Public Service of New Hampshire

SBN-1192
T.F. B7.1.2

Subject: Additional Comments on Seabrook Station Technical Specifications.

ATMOSPHERIC RELIEF VALVES

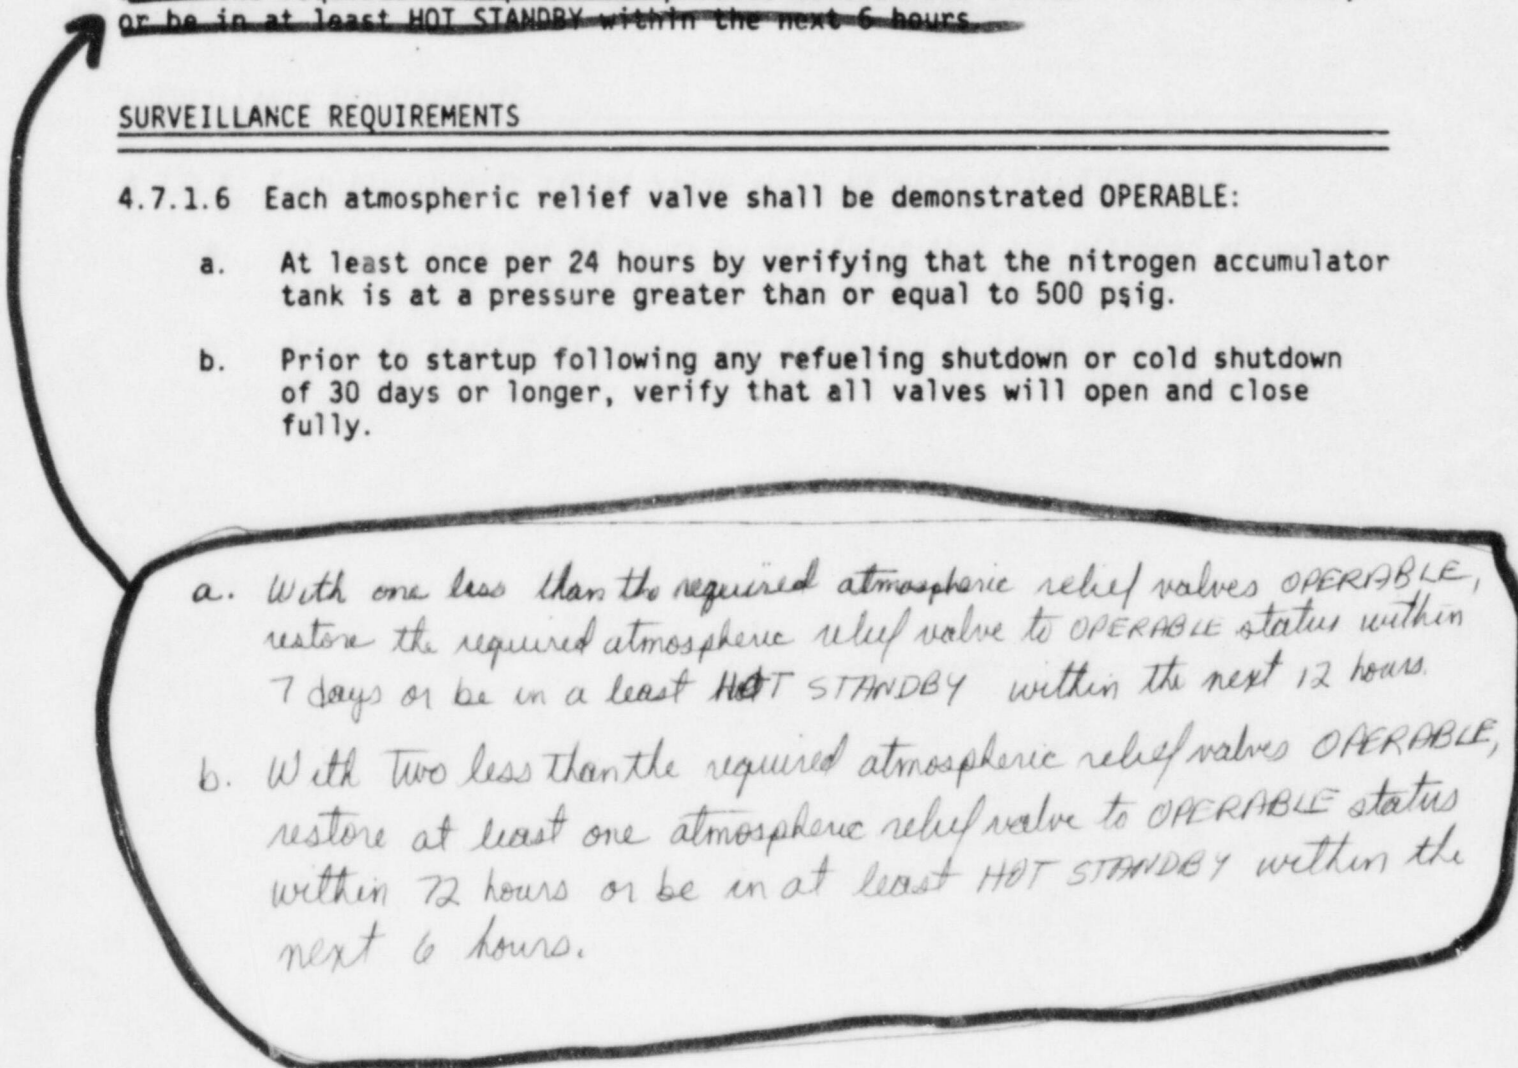
~~With less than one atmospheric relief valve per steam generator OPERABLE, restore the required atmospheric relief valve to OPERABLE status within 72 hours, or be in at least HOT STANDBY within the next 6 hours.~~

- 
- a. With one less than the required atmospheric relief valves OPERABLE, restore the required atmospheric relief valve to OPERABLE status within 72 hours or be in at least HOT STANDBY within the next 12 hours.
 - b. With two less than the required atmospheric relief valves OPERABLE, restore at least one atmospheric relief valve to OPERABLE status within 72 hours or be in at least HOT STANDBY within the next 6 hours.
